A585 Windy Harbour to Skippool Improvement Scheme

7.11 Environmental Statement Changes and Corrections Document

Environmental Statement Changes and Corrections Document

Regulation Number:	Regulation 5(2)(q)
Planning Inspectorate Scheme Reference	TR010035
Application Document Reference	TR010035/APP/7.11
Author:	A585 Windy Harbour to Skippool Improvement Scheme Project Team, Highways England

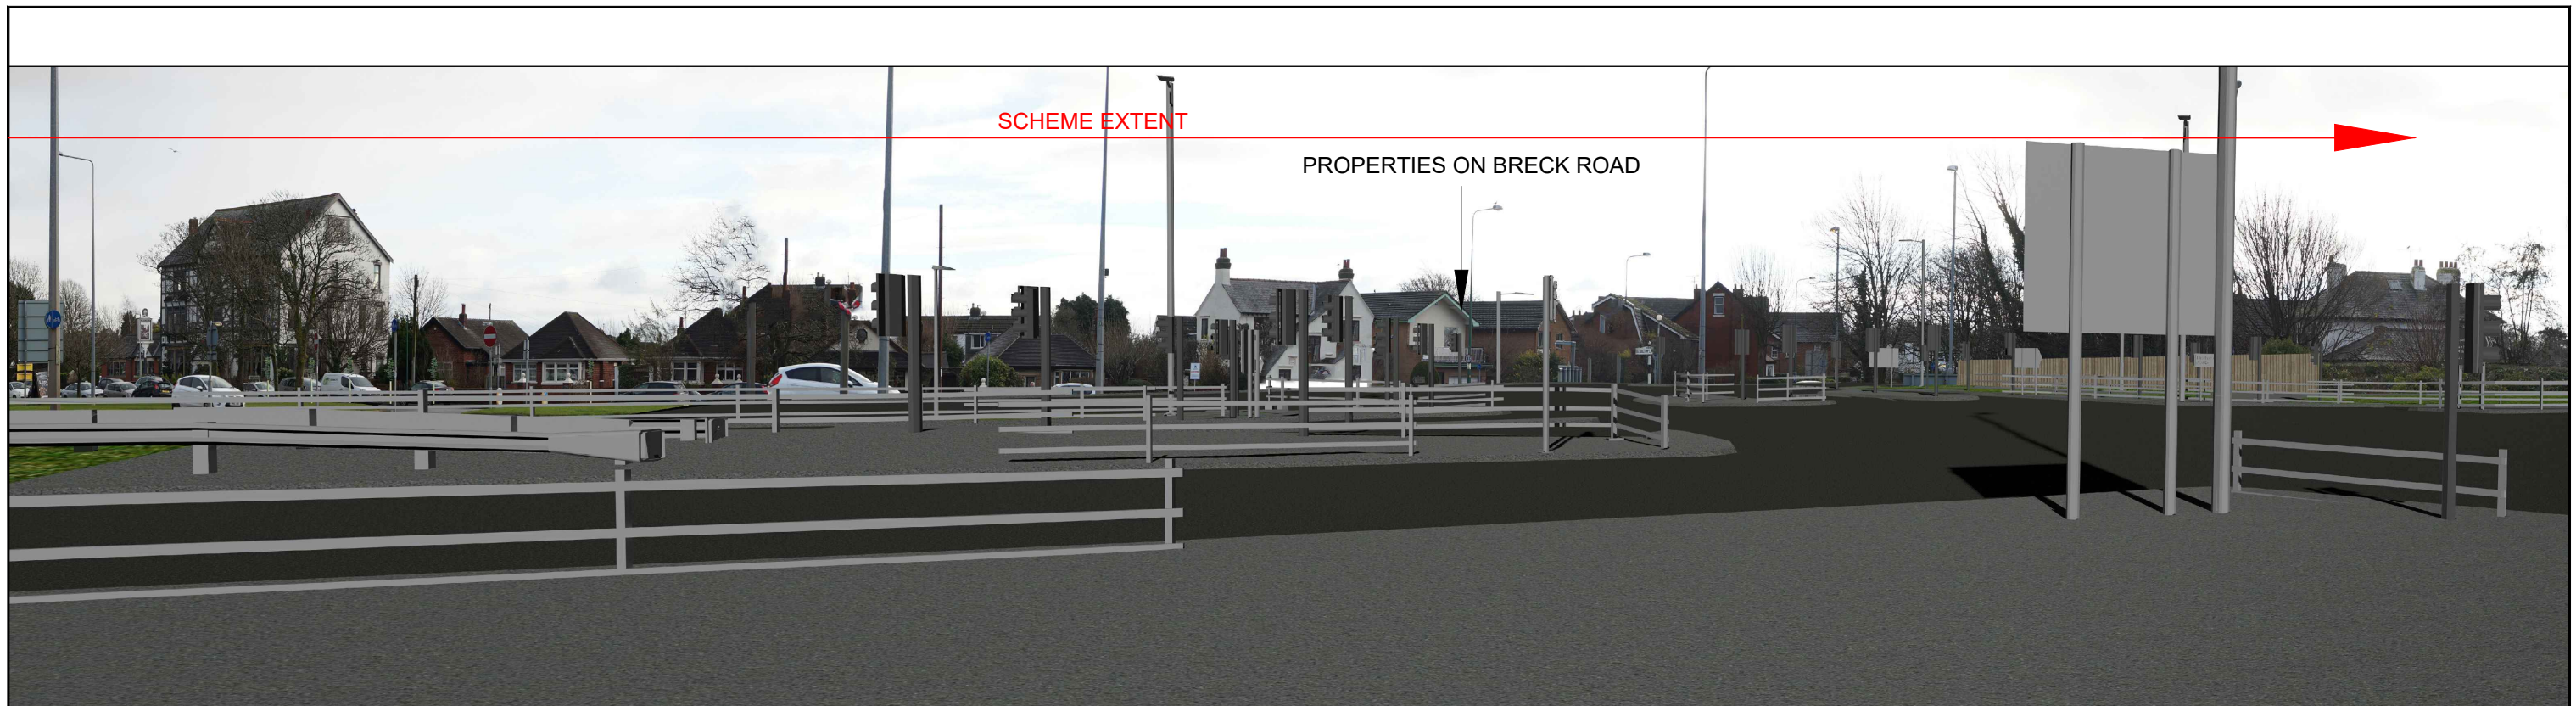
Document Reference Number	Document Name	Amendment Required	Reason									
6.9	ES Chapter 9: Landscape	Update to Figure 9.10, Photomontage at Viewpoint Location 1, view from Breck Road / Wyre Way at the A585 provided within Appendix C.	Updated to show the provision of a fence at 183 Breck Road.									
6.9	ES Chapter 9: Landscape	Update to Figure 9.10, Photomontage at viewpoint location 2 – Revision 2 , view from residential properties on Breck Road provided within Appendix C.	As a result of updates to the Flood Risk Assessment associated with the dwarf wall and the provision of a fence at 183 Breck Road.									
6.9	ES Chapter 9: Landscape	Update to Figure 9.10, Photomontage at viewpoint location 10, view from the B5260 Lodge Lane provided within Appendix C.	Updated to show the 3m high acoustic barrier to the north of the cutting.									
6.9	ES Chapter 9: Landscape	Update to Figure 9.10, Photomontage at viewpoint location 9, view from the A585 Garstang New Road provided within Appendix C.	Updated to show the additional linear planting adjacent to Grange Footbridge, as a result of request from Fylde Borough Council (document reference TR010035/APP/7.9).									
6.9	ES Chapter 9: Landscape	Update to Table 9-16

Project: A585 WINDY HARBOUR TO SKIPPOOL IMPROVEMENT SCHEME
 Drawing Title: ENVIRONMENTAL STATEMENT REGULATION 5(2)(a) NOISE AND VIBRATION: NOISE MITIGATION SHEET 1 OF 6

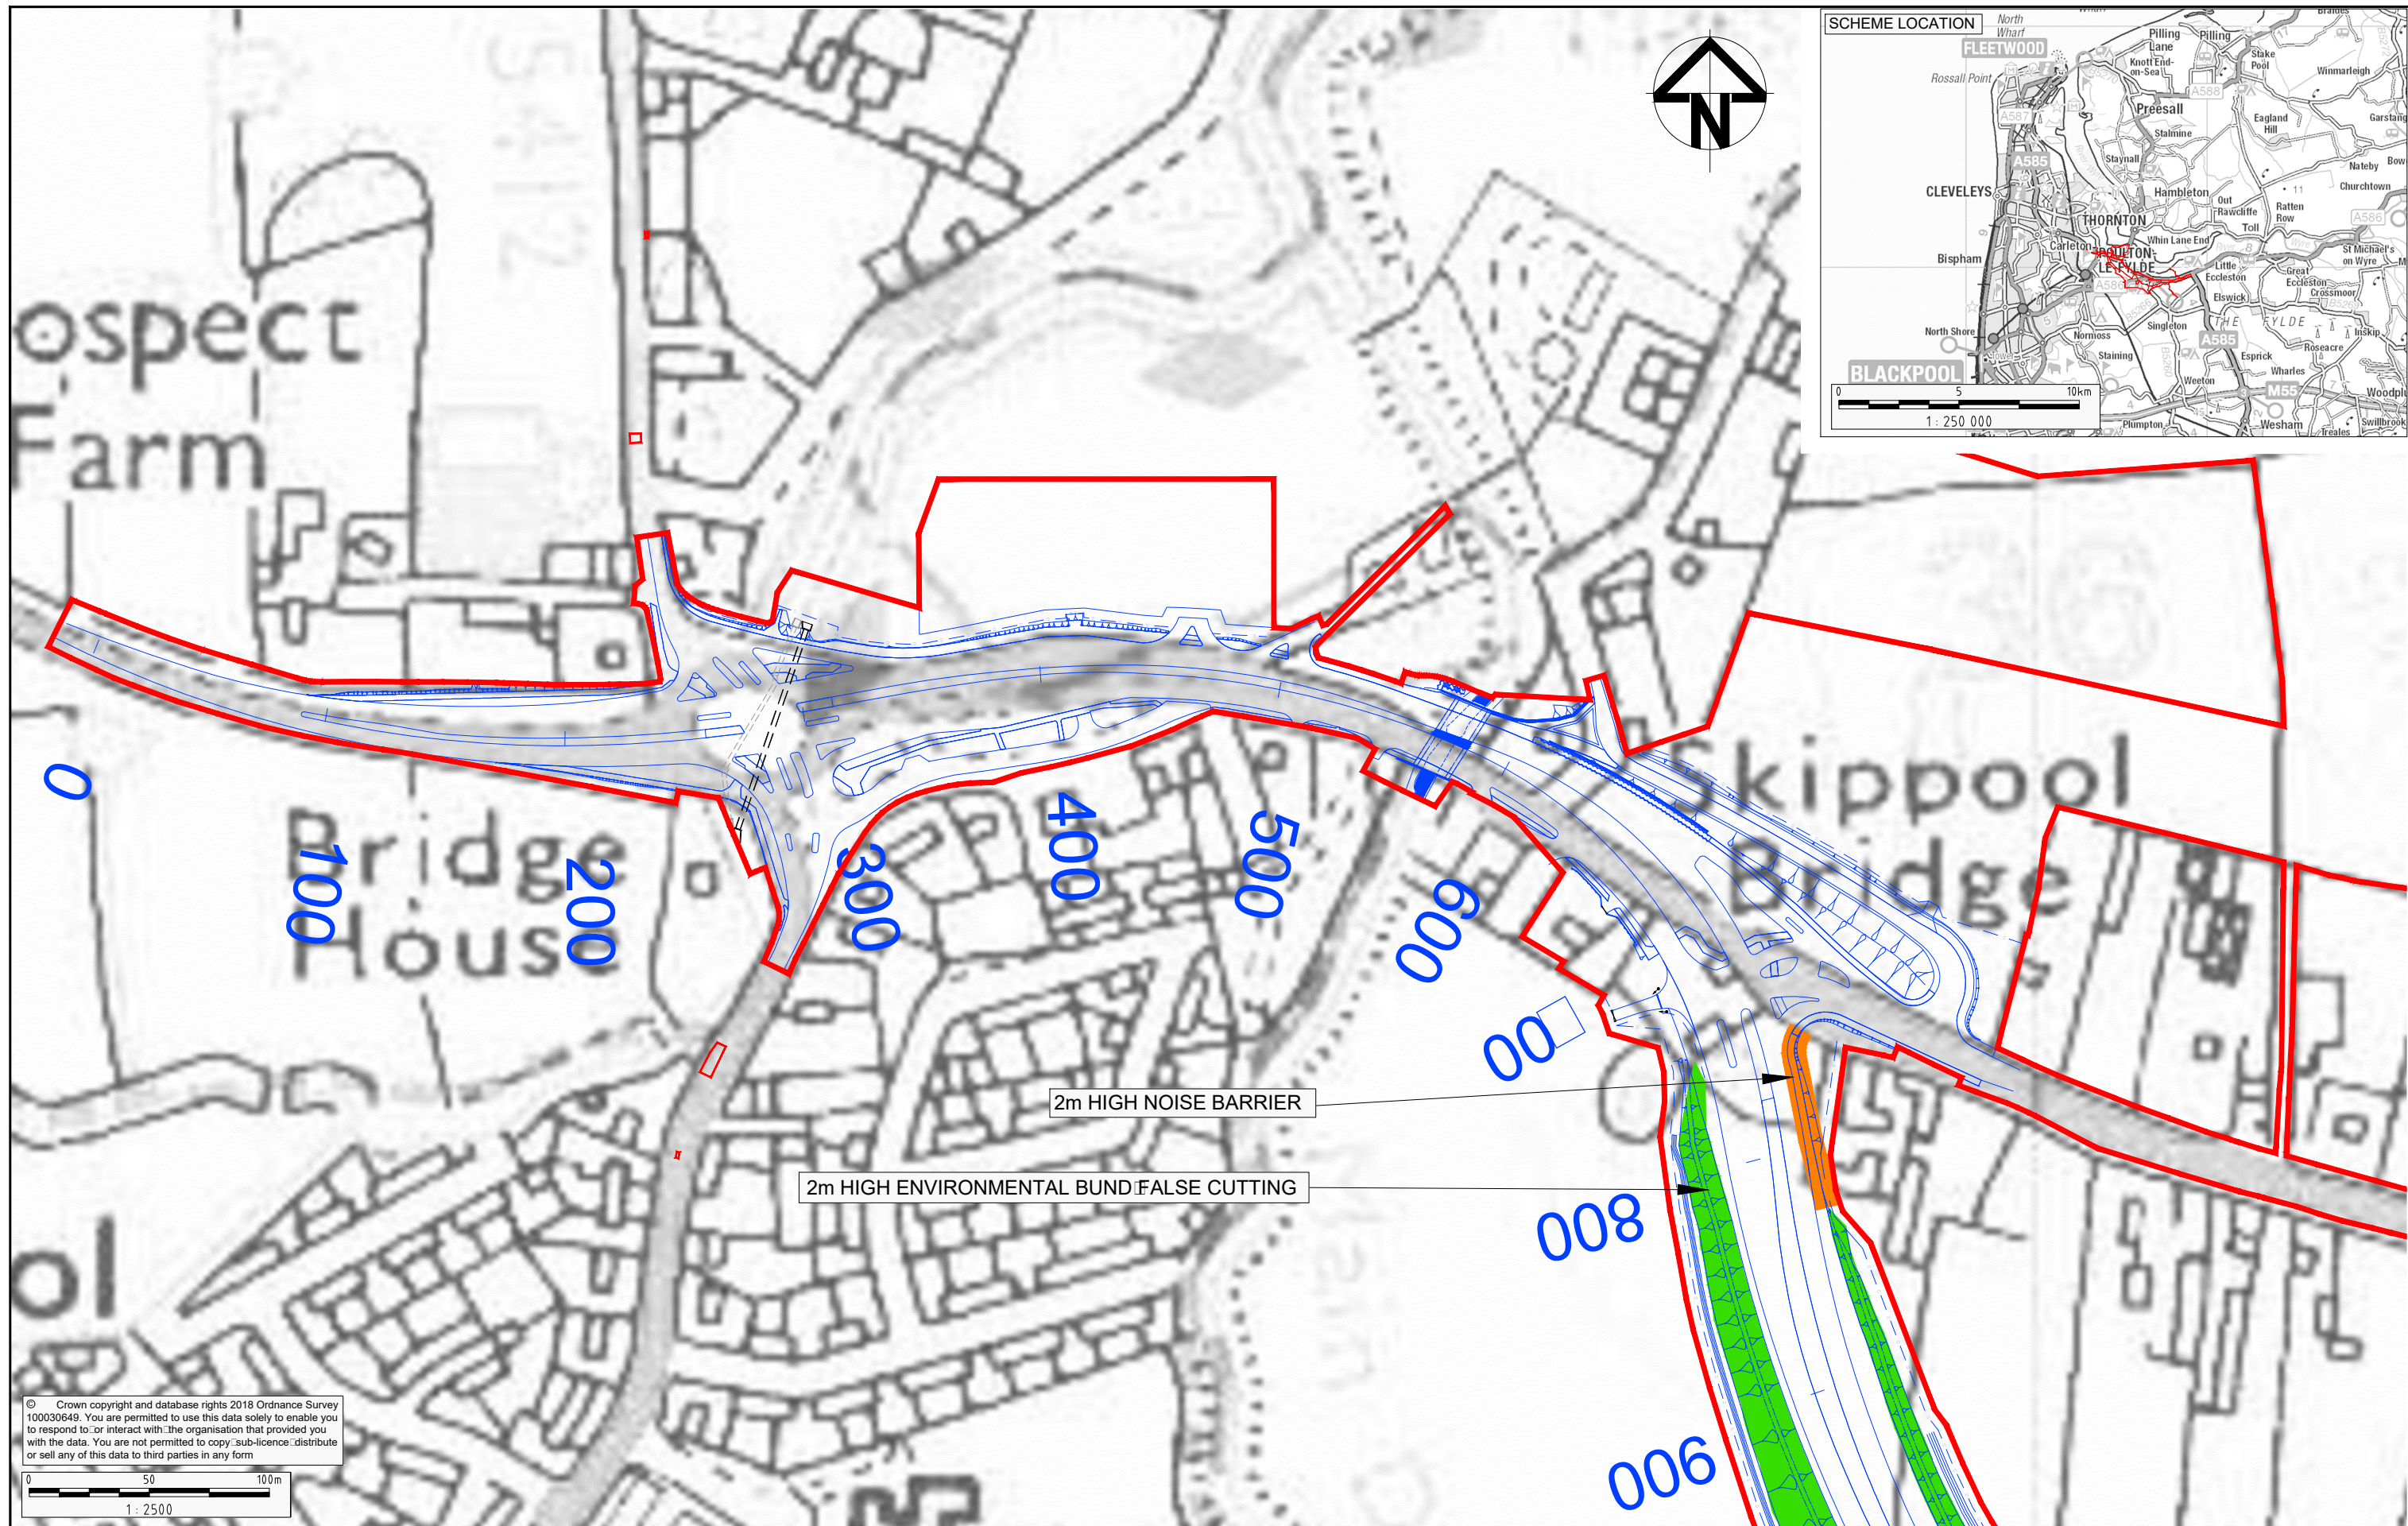
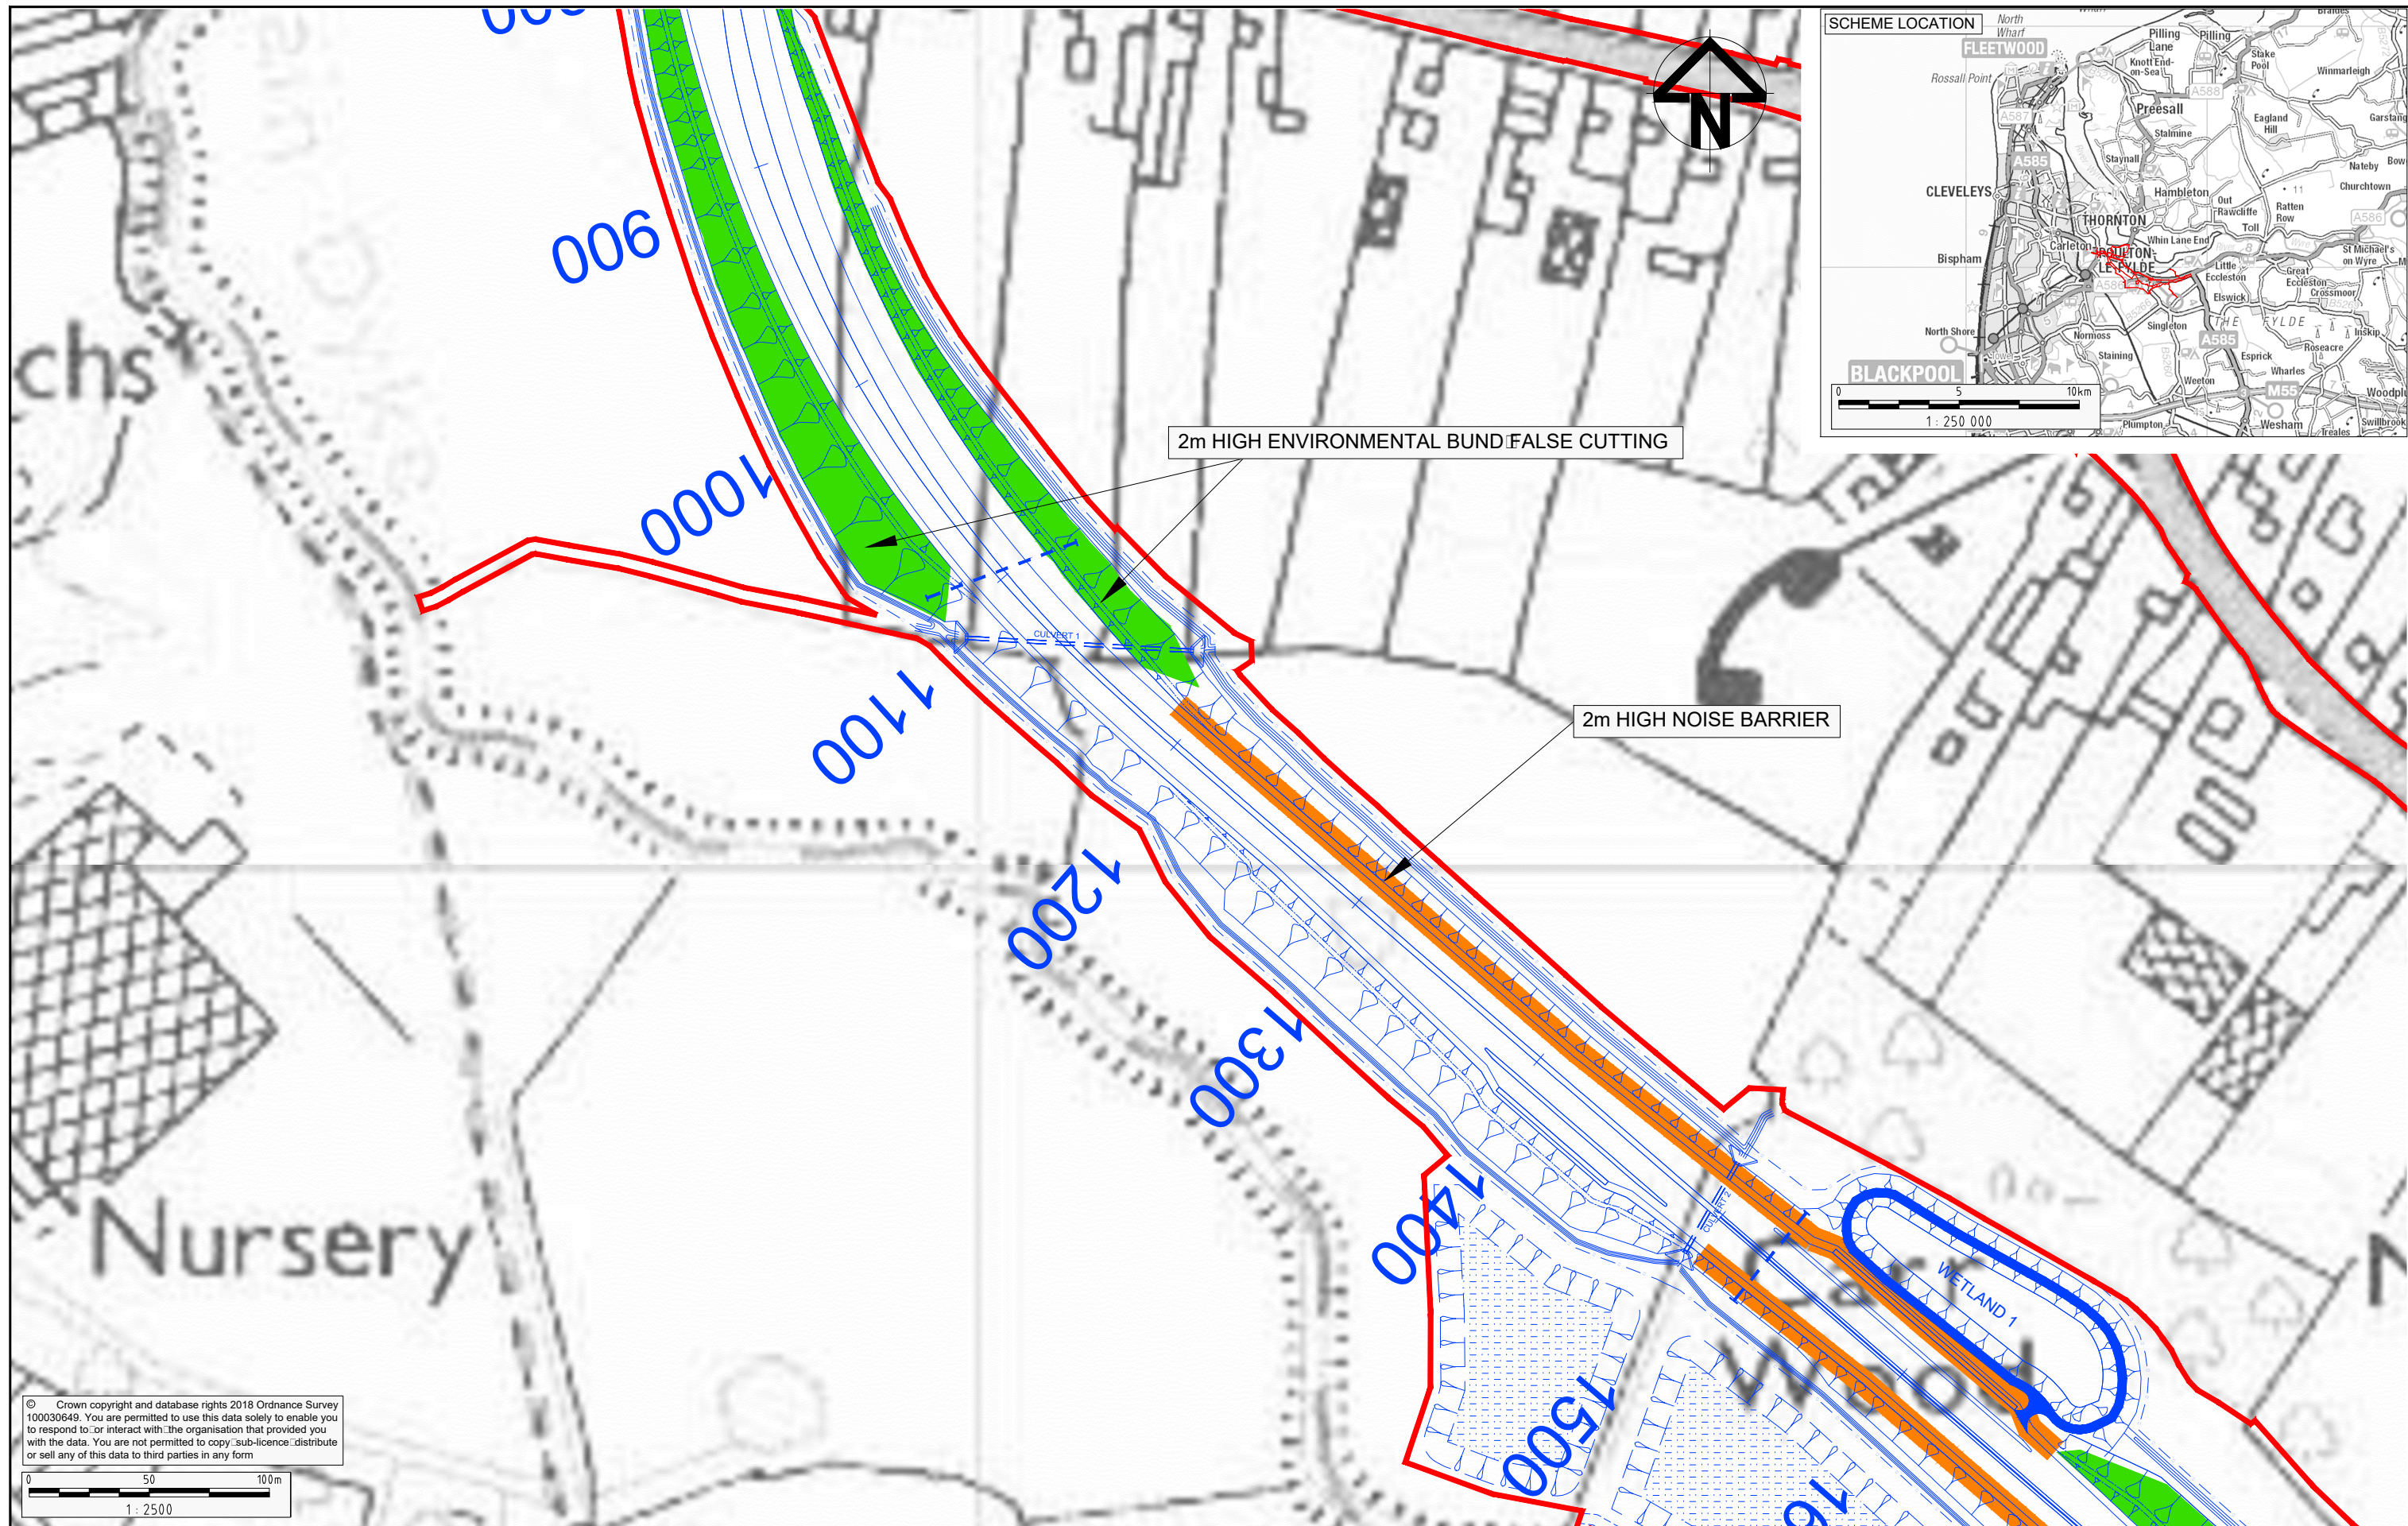
Document Reference Number	Document Name	Amendment Required	Reason
			TR010035/APP/7.10).
6.11	ES Chapter 11: Noise and Vibration	Update to Figure 11.4: Noise and Vibration – Noise Mitigation within the Study Area presented at Appendix D to show heights and locations of earth mounds and acoustic fencing at a larger scale.	Requested by the Inspector within the first round of written questions (document reference TR010035/APP/7.10).
